ADDENDUM #6

PROJECT : CODESTACK ACADEMY

REF. # : ARCH PROJ. No. 2023-04

DATE : 21 March 2025

S2.2

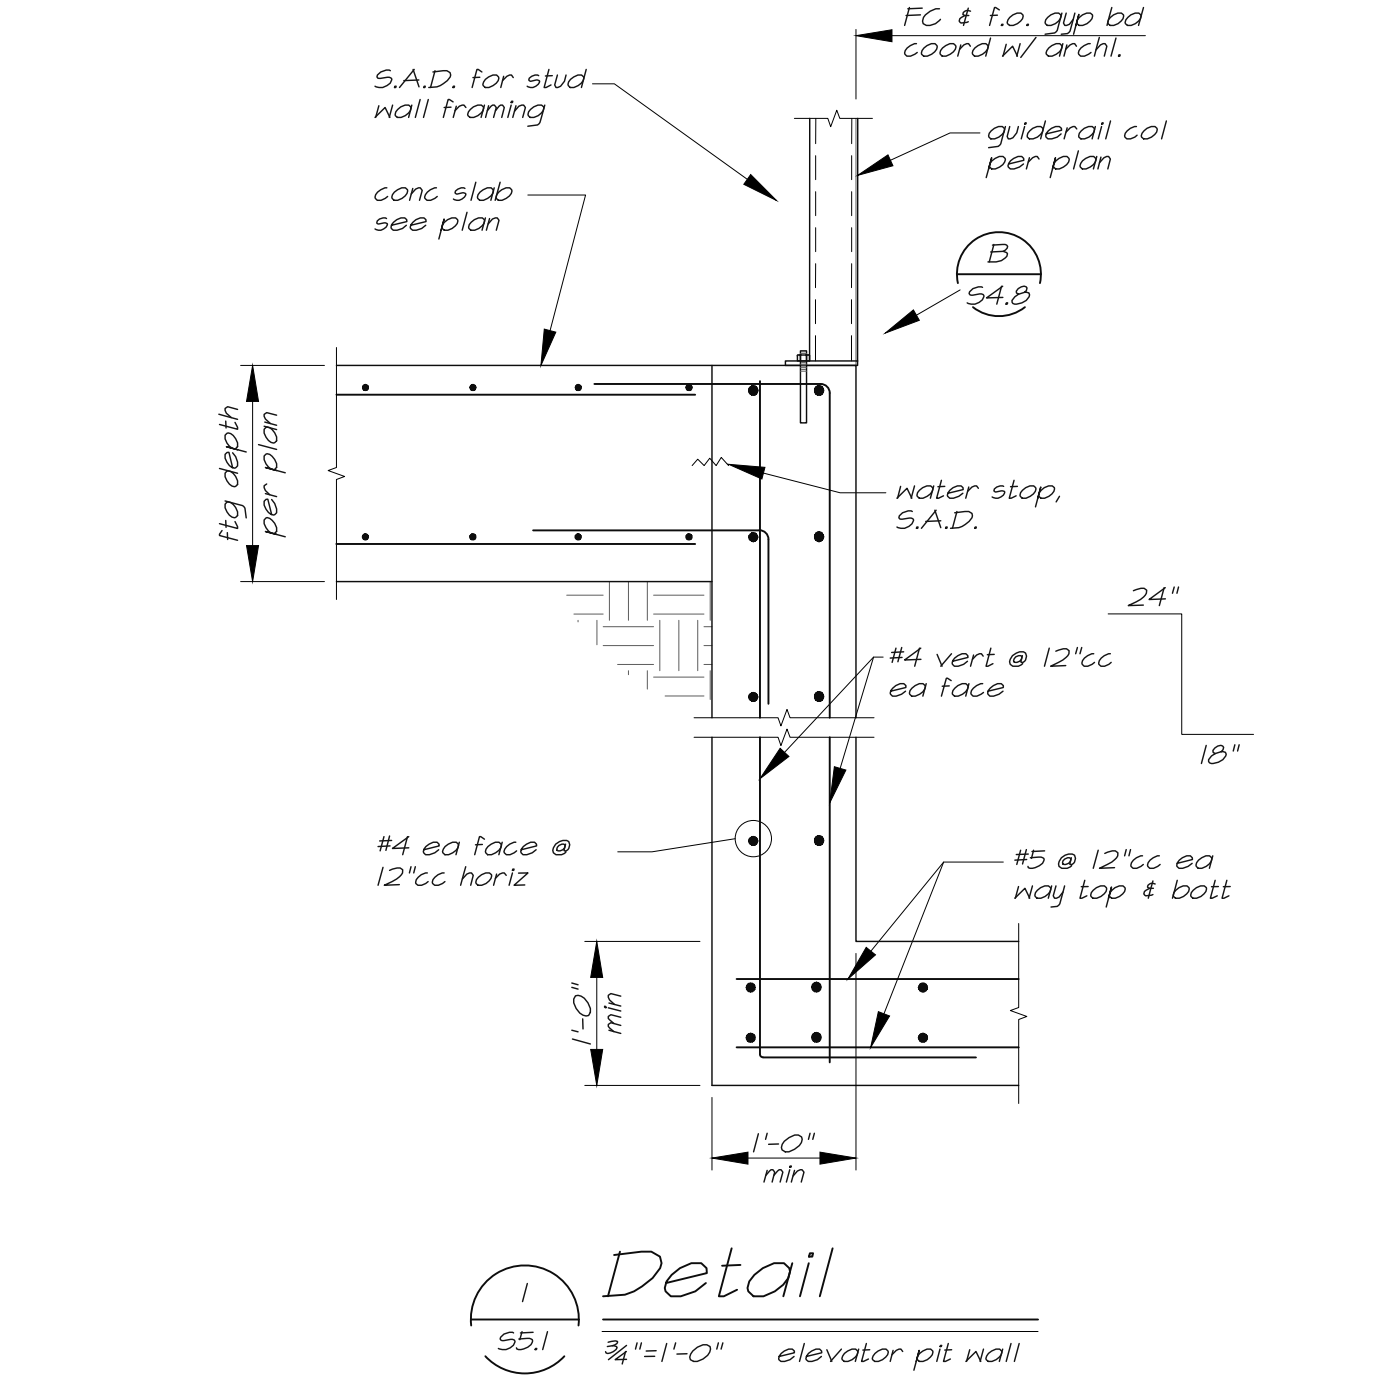
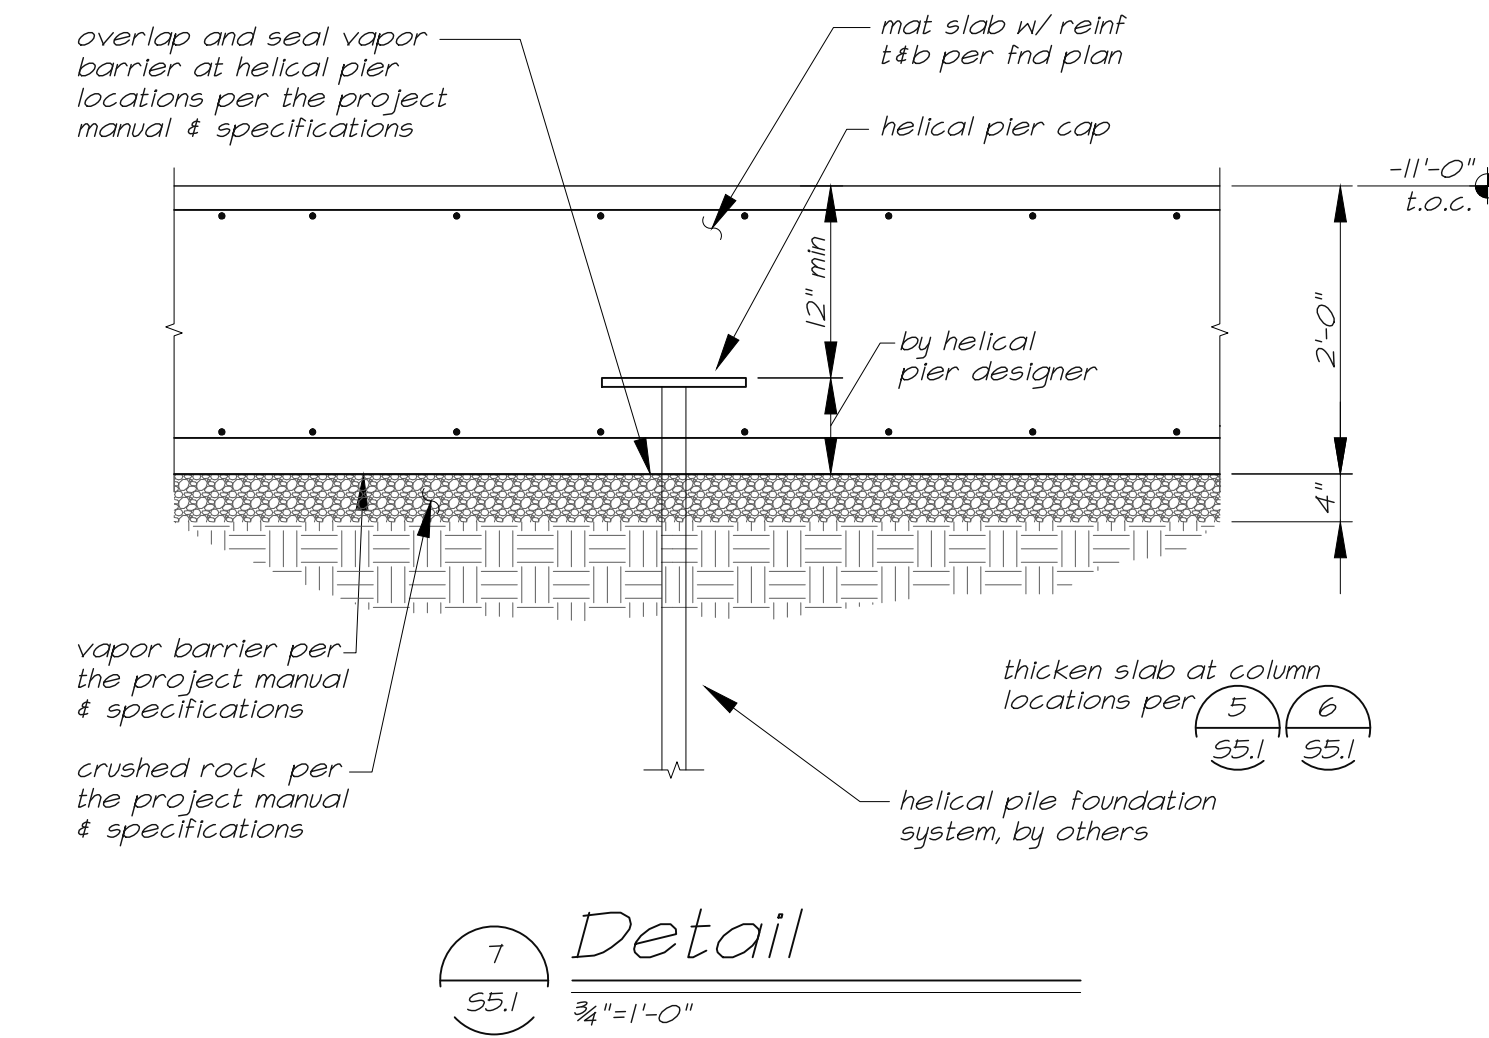
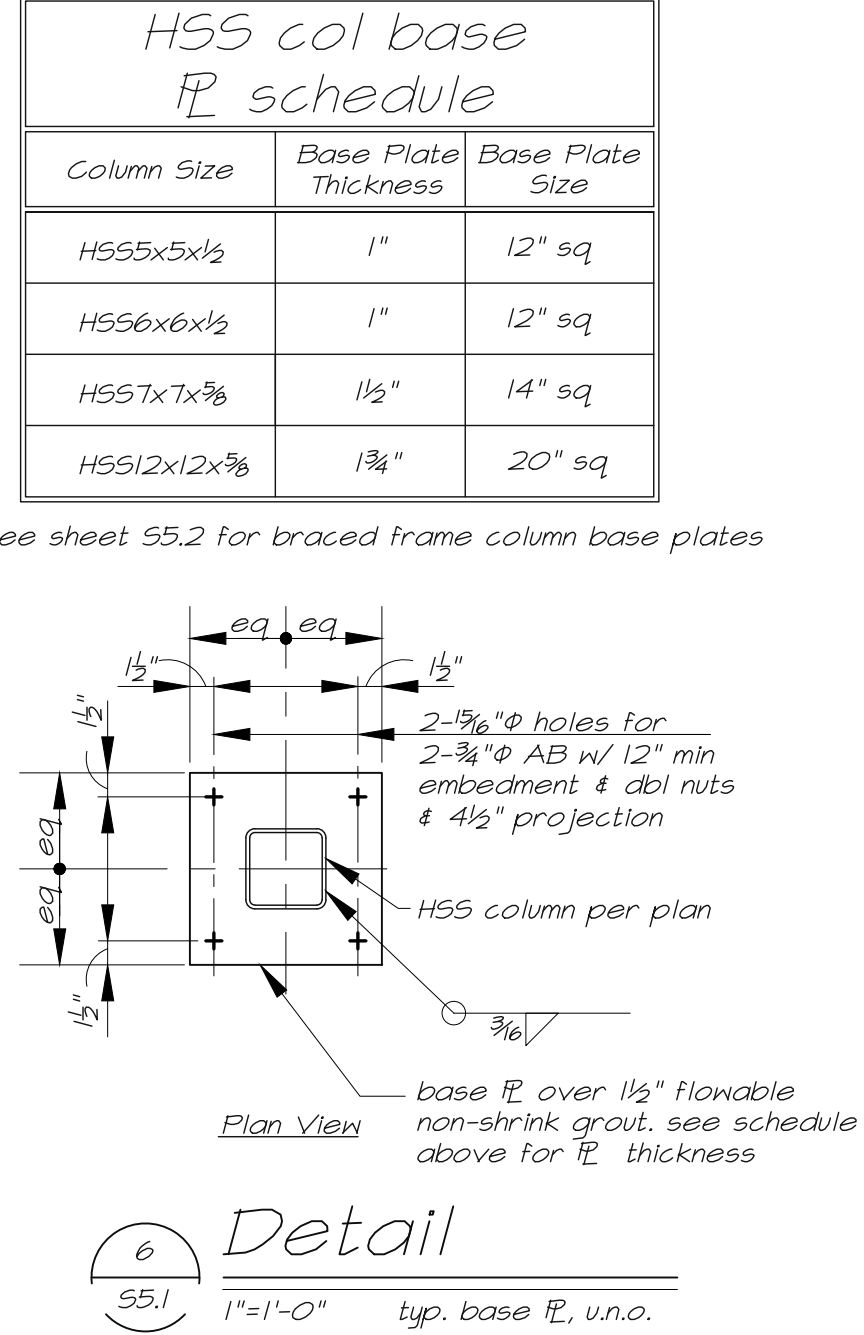
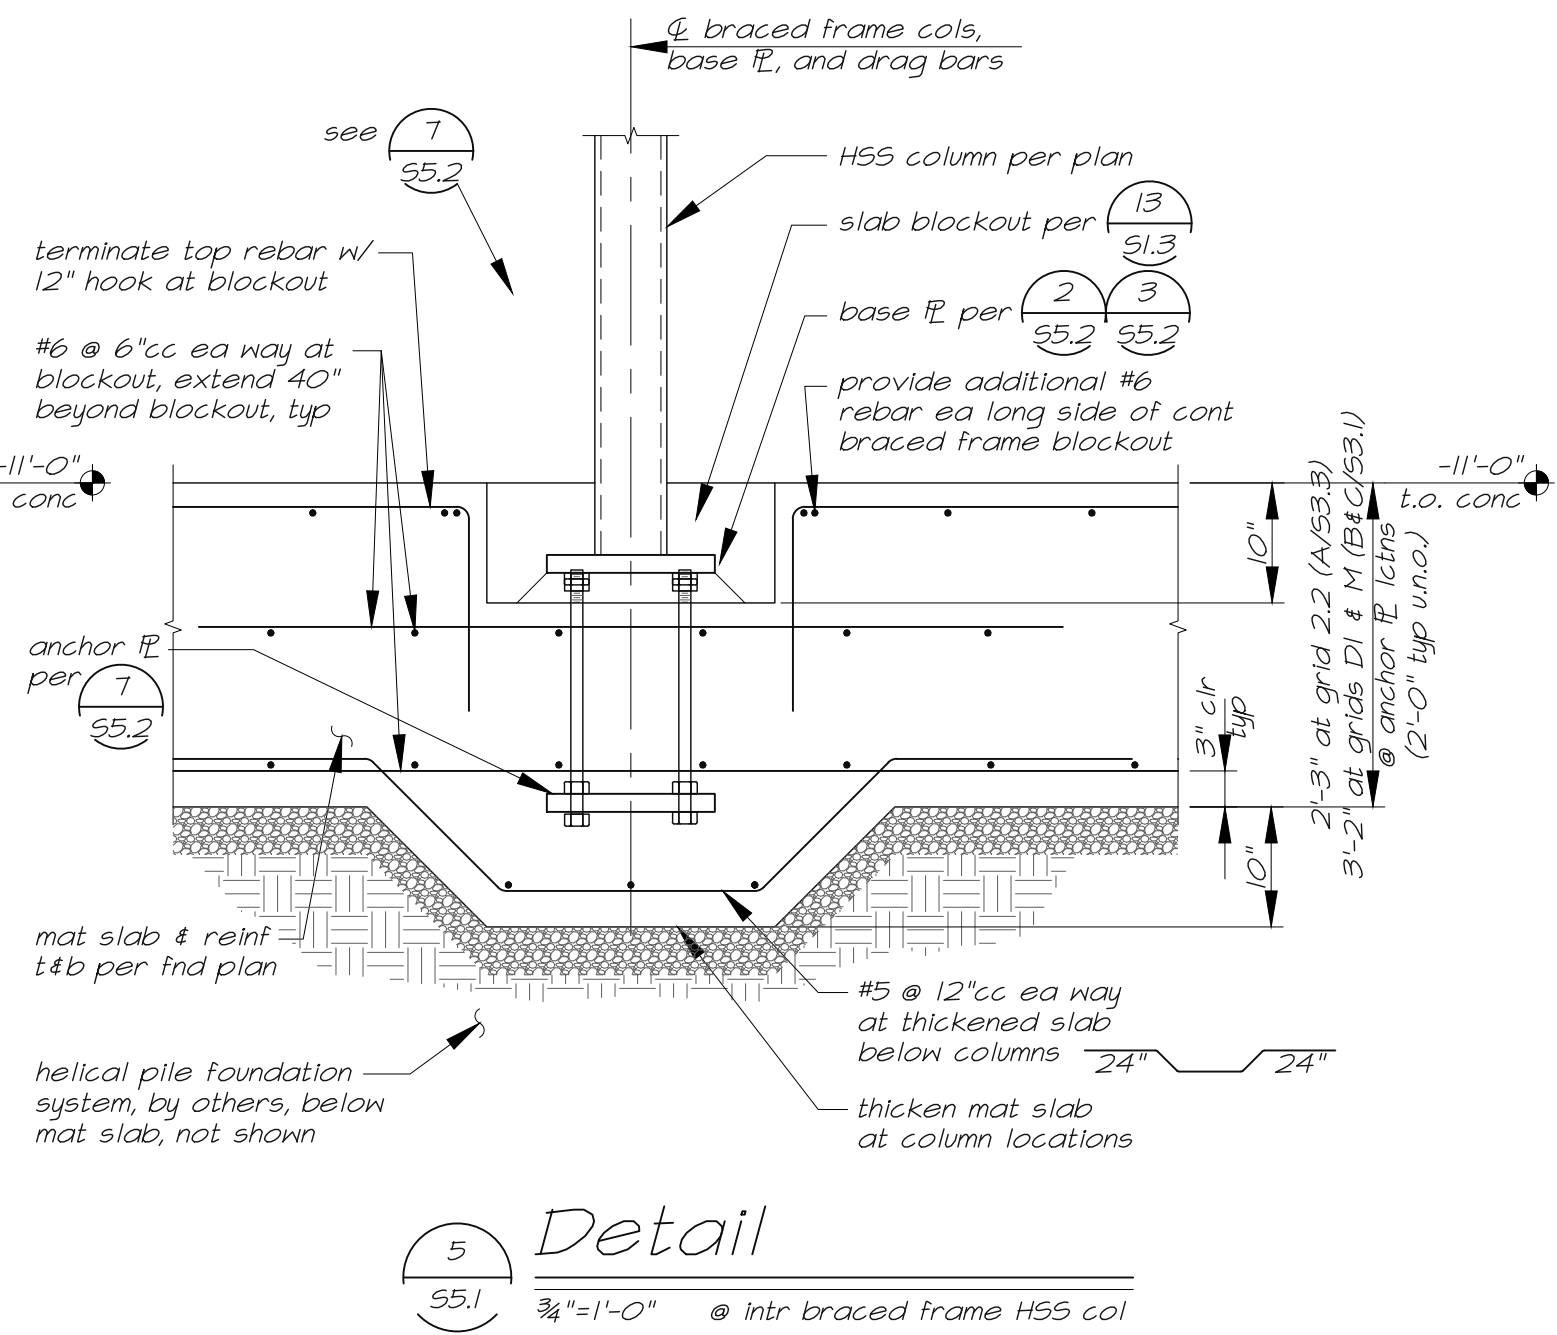
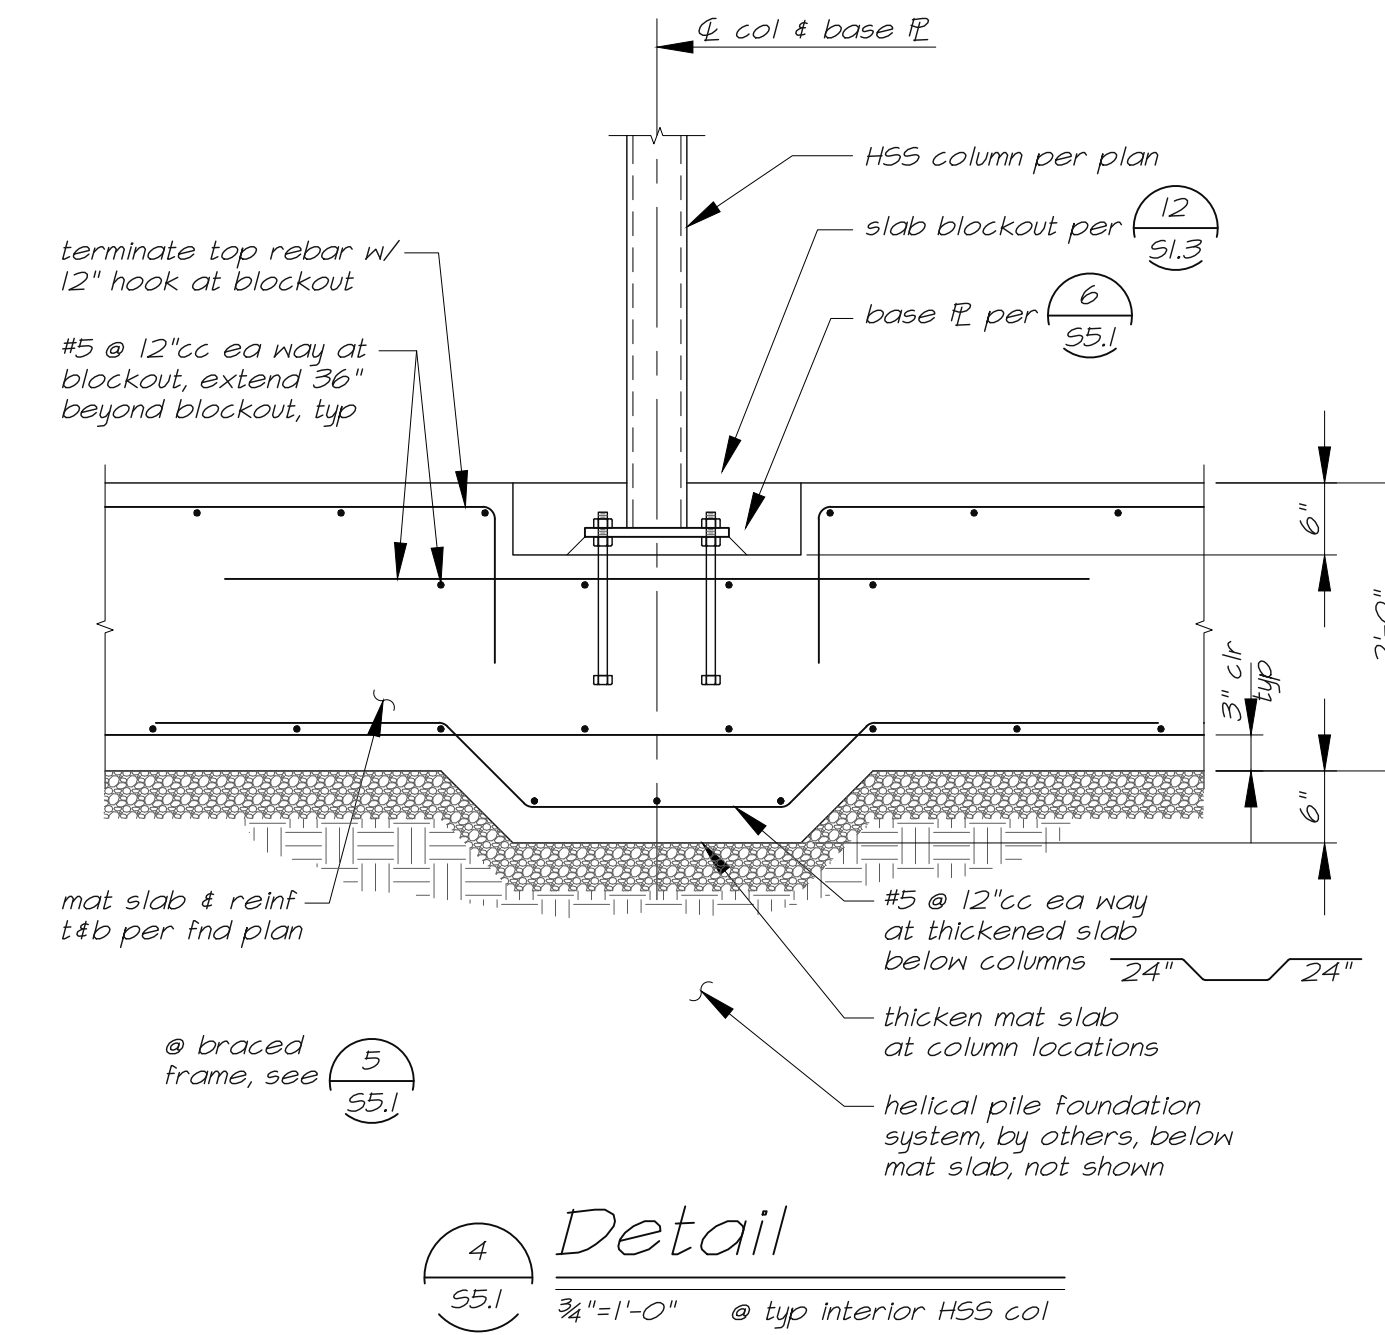
Please confirm if the existing footings along GL9 are continuous or spread footings centered on the existing columns.

Underpinning is noted to extend the full width of the existing footings, please clarify the assumed size of the existing footings for bidding purposes.

The new concrete basement wall along GL's A.2 and Q.2 between GL's 1 & 4 in the structural floor plans does not align with the same wall on the architectural floor plans. The location of the wall as shown on the structural floor plan could create coverage issues for the base plate anchorage at A.2/2.2 and A.2/3.

RESPONSE: It is assumed that there are spread footings at each of the existing concrete columns, but there is no documentation to confirm this.

RESPONSE: Unknown, bid as shown.

RESPONSE: Unless otherwise detailed on the architectural drawings, these columns can bear at the top of the concrete, similar to detail 9/S5.6. Verify with architectural drawings.
